**WHEELING PLAN COMMISSION
THURSDAY, AUGUST 10, 2017 6:30 P.M.**

REQUEST FOR PLAN COMMISSION ACTION
STAFF PROJECT REVIEW

RE: **Docket No. SCBA 17-14**
Heritage Park
333 W Dundee Road
Appearance Approval of Monument Signs

RE: **Docket Nos. PC 17-14 and SCBA 17-31**
Burger King
425 W. Dundee Road
(PC 17-14) Site Plan Change to Special Use Ordinance No.
1997 for Building and Site Modifications to an
Existing Drive-Thru Restaurant
(SCBA 17-31) Appearance Approval of Wall Signs

SD 1.0

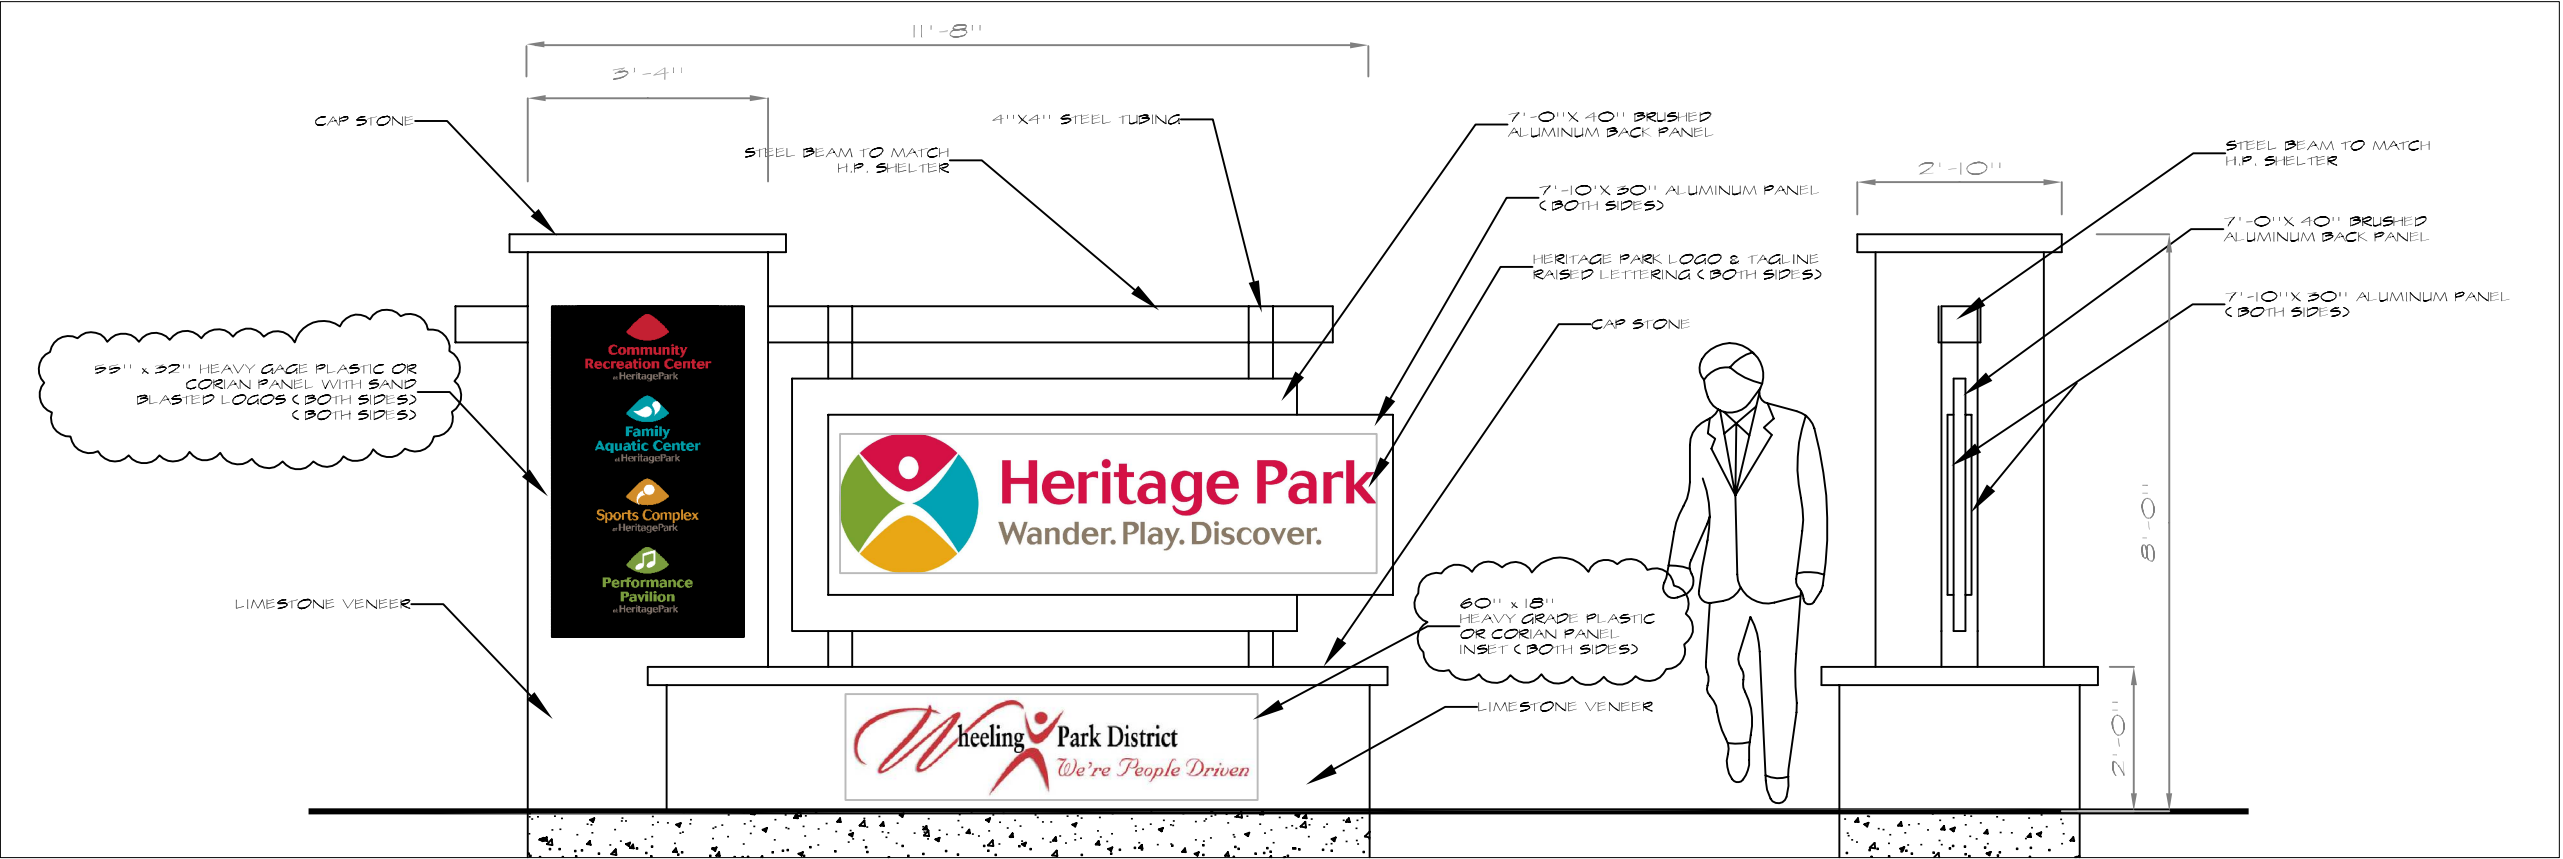
DATE	REVISION
07/28/17	SETBACK DIMENSIONS DIMENSIONS ADDED AS REQUESTED
